Model: AGL-C1	Date: 15-Jan-10	No.: RD097001d
---------------	-----------------	----------------

Subject: Firmware Release Note: Engine		Prepared by: H.kawamura	
From: PPBG Service Planning Dept.			
Classification:	<input type="checkbox"/> Troubleshooting <input type="checkbox"/> Mechanical <input type="checkbox"/> Paper path <input type="checkbox"/> Product Safety	<input type="checkbox"/> Part information <input type="checkbox"/> Electrical <input type="checkbox"/> Transmit/receive <input checked="" type="checkbox"/> Other (Firmware)	<input type="checkbox"/> Action required <input type="checkbox"/> Service manual revision <input type="checkbox"/> Retrofit information <input type="checkbox"/> Tier 2

Model: AG-P1/C1, AGL-P1/C1, Aries-P1.5/C1.5	Date: 06-Dec-10	No.: RG178128c
---	-----------------	----------------

Subject: Notes on Handling PCDUs to prevent drum scratching		Prepared by: H. Kawamura	
From: PPBG Service Planning Dept.			
Classification:	<input checked="" type="checkbox"/> Troubleshooting <input type="checkbox"/> Mechanical <input type="checkbox"/> Paper path <input type="checkbox"/> Product Safety	<input type="checkbox"/> Part information <input type="checkbox"/> Elec

56.Fusing Unit 5 (D016/G178)

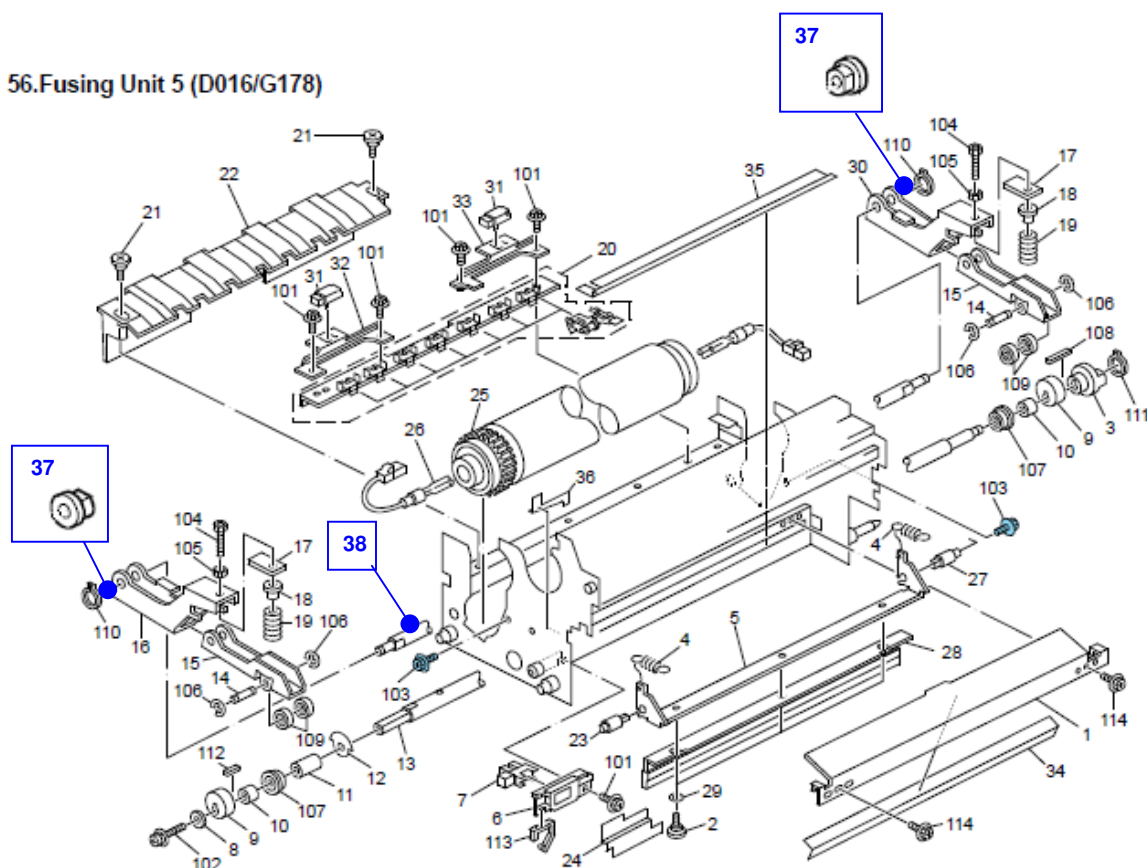
*1) Parts indexed 37 and 38 are service parts newly added for the modified fusing unit.

54.Fusing Unit 3 (D016/G178)

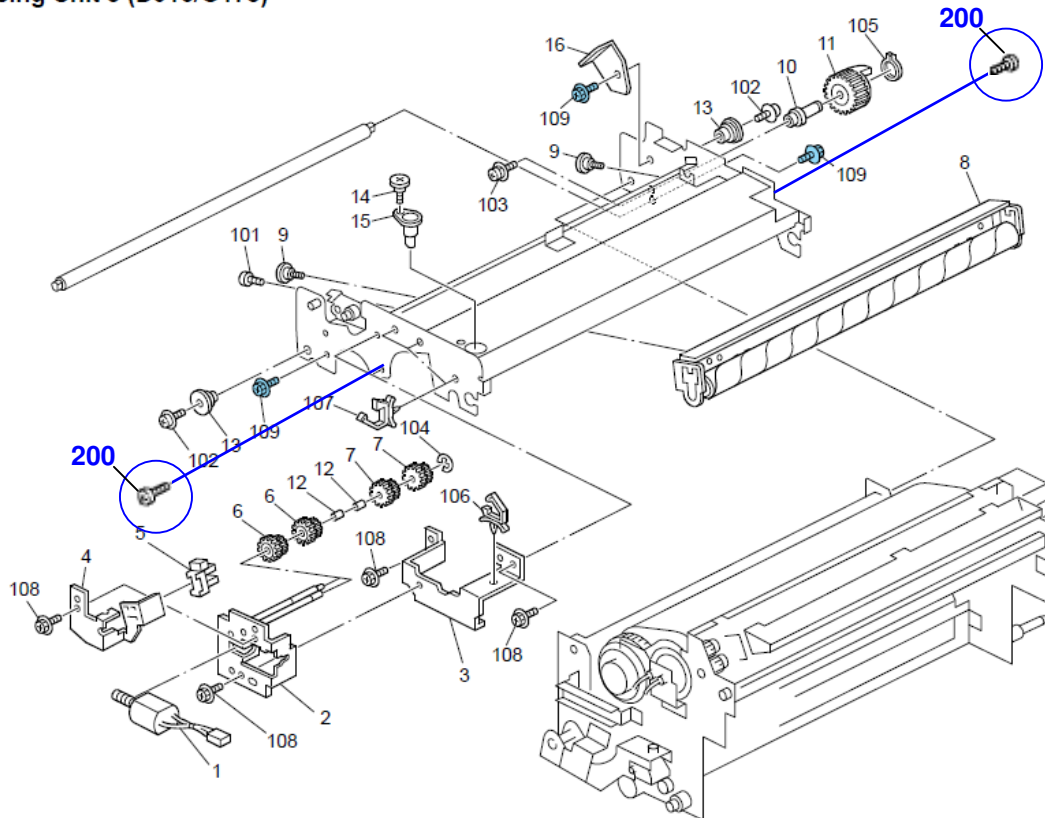
*2) The screws indexed 200 have been added to the locations shown in the diagram below in the modified fusing unit.

Index No.200
P/N AA143803
FLANGED HEXAGONAL HEAD BOLT:CASTER

1. Fusing unit

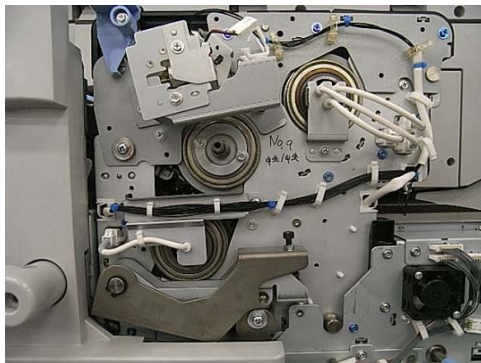
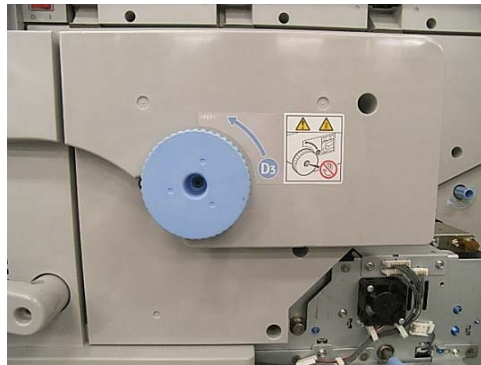
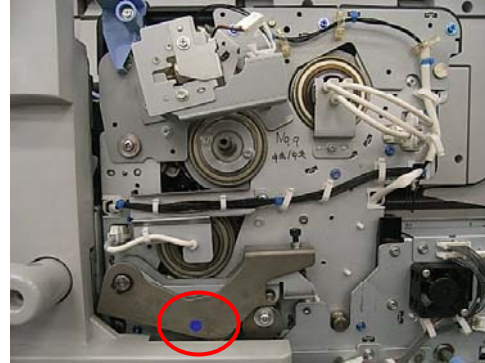
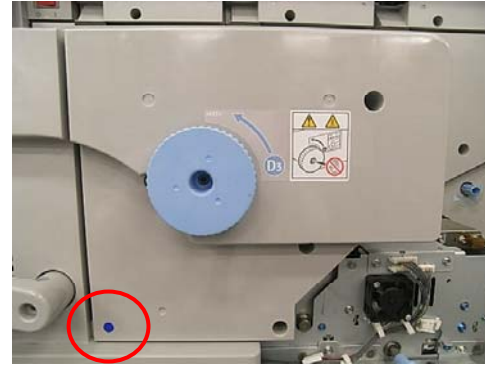
Although the units can be distinguished by the p/n indicated on the packaging boxes, it could be tricky after the units are installed in the mainframe. To enable distinction, the modified units are marked with blue stickers on the cover and the arm as shown in the photos above.

4. Pressure Arm

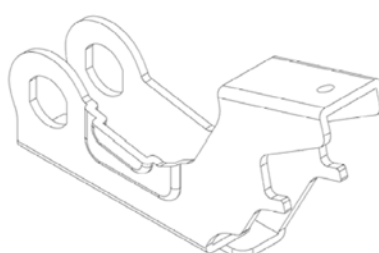
The arm for the standard unit is not durable enough to operate the modified unit and will cause the shaft to wear. The arm for the modified unit made of thicker plate is installed with a bushing to prevent wear and also has a different shape.

5. Rear Cover

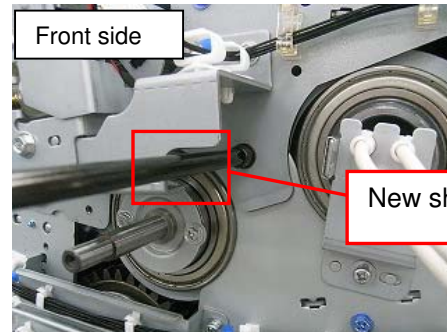
To avoid contact between the ribs on the cover and the pressure arm caused by the shape change of the pressure arm, the ribs on the cover have been partially removed.

6. Addition of Securing Screws

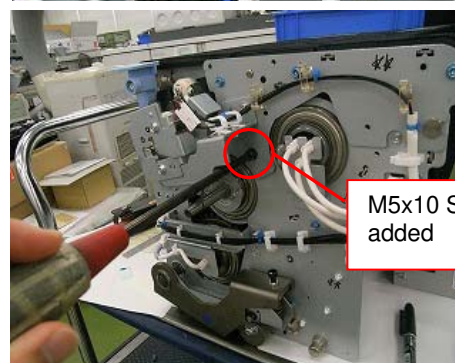
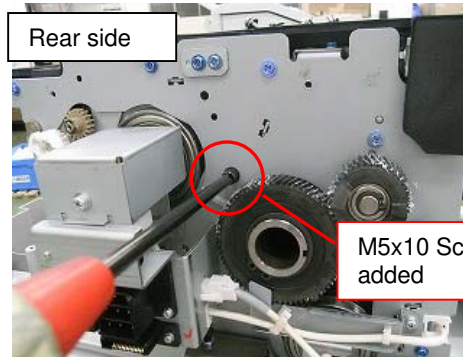
Screws to attach the upper and lower frames have been newly added to secure higher durability of the entire unit and Bracket:Web:Drive(p/n:G1784354) has been changed in shape to allow easy access to the screw.

P/N of the newly added M5x10 screw:

AA143803 / FLANGED HEXAGONAL HEAD BOLT:CASTER

114.ADF 9 (D095)

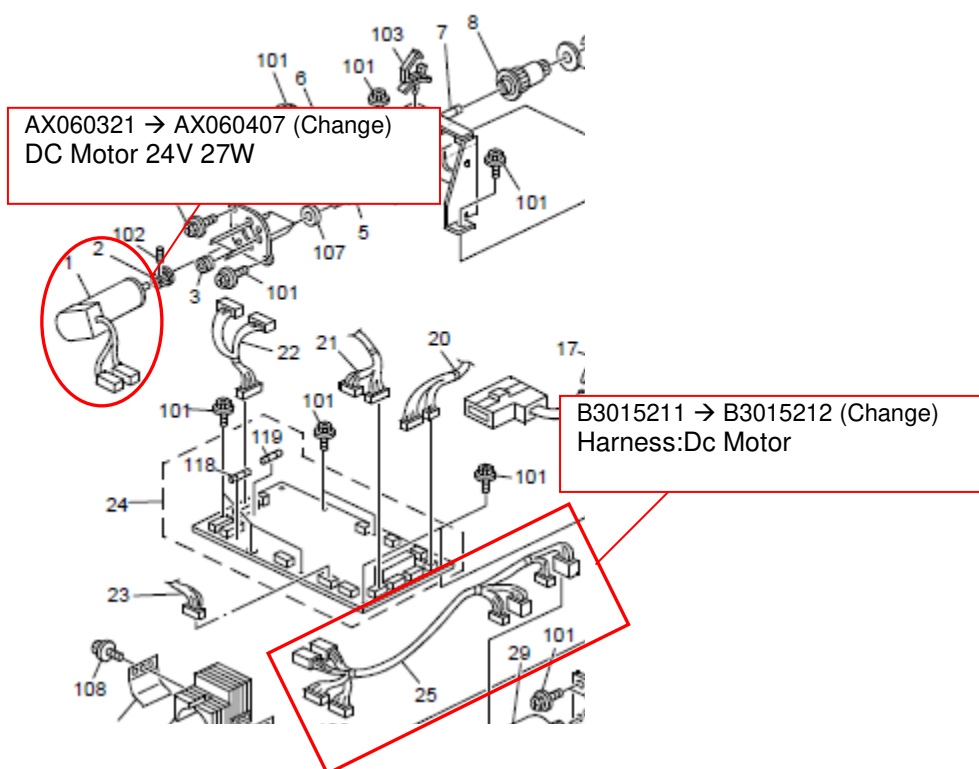
Change: Motor and harness

Reason: The factory of the motor has changed; the harness connecting the motor needs to be replaced together with the motor.

Old Part Number	New Part Number	Description	Q'ty	Int	Page	Index	Note
B3015211	B3015212	Harness:Dc Motor	1	X/X	253	25	Replace as set
AX060321	AX060407	DC Motor 24V 27W	1	X/X	253	1	Replace as set

NOTE: Motor and Harness need to be replaced as a set.
 Motor and Harness interchangeability is X/X individually, and O/O.as a set.
 This change has been applied from 2011 November production.
 This change is also applied to ProC900S, ProC720S
